SPORTON LAB

Response For FCC Application 2005/6/14

RE: Benq

FCC ID: JVP57P50

Keypad down

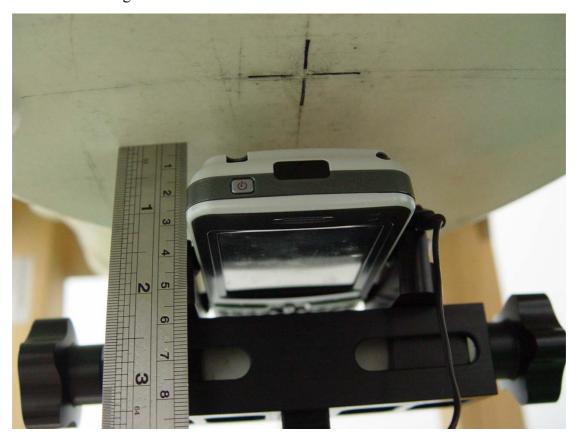
1. Please find the SAR setup photo with 1.5 cm gap configuration as attached.
